Re: Design Exception #06-21- 676 Peony Dr. – Length of Shared Driveway

DESIGN EXCEPTION # 6-21

RE: Hutto Annexation and Sub. 676 Peony Dr. – Length of Shared Driveway

676 Peony Drive

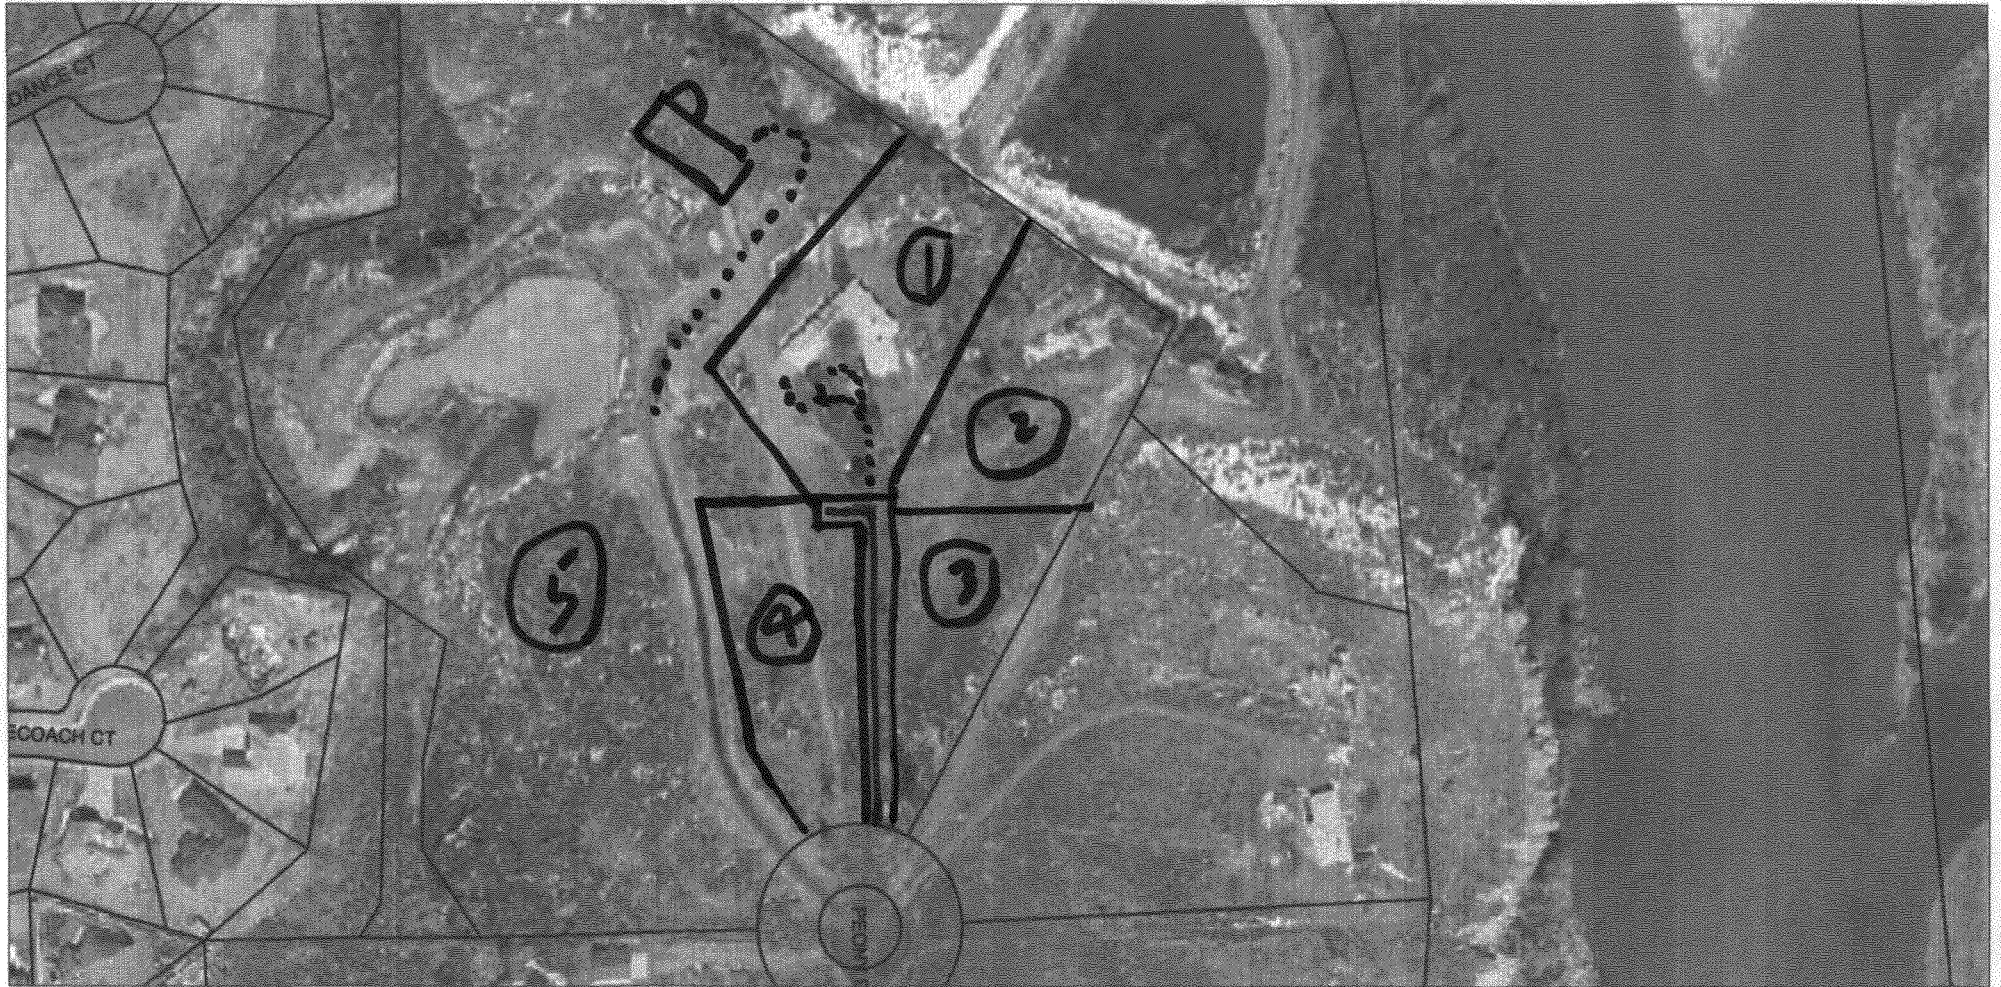
As shown on the attached print we would like to include a shared driveway for four lots in our proposed subdivision. While the regulations provide for a shared driveway of a maximum length of 150 ft, the practical shared driveway in our proposed subdivision would be about 300 ft long.

We considered putting a cul-de-sac on the end of our property between the current cul-de-sac and the required 150 ft shared driveway, but this would be both expensive and impractical since a cul-de-sac already exists. A shared driveway out of the present cul-de-sac would be the most practical, obvious solution.

Peony Drive is a long cul-de-sac located in the County which intersects with Broadway. The applicant's proposed shared drive would include a hammer-head turnaround, and is approximately 300' long. TEDS limits shared drives to 150' of length.

- 1. Will the exception compromise safety?**
Staff does not believe the exception will compromise safety.
- 2. Have other alternatives been considered that would meet the standard?**
Yes. It is possible to simply extend the cul-de-sac into the property, but the cul-de-sac is already very long (approximately 4000-ft). It is also possible to reduce the number of lots, making the shared drive unnecessary.
- 3. Has the proposed design been used in other areas?**
Staff is not aware of any other examples of shared drives longer than 150'.
- 4. Will the exception require CDOT or FHWA coordination?**
No.

Staff recommends denial of the exception requested.

Denied
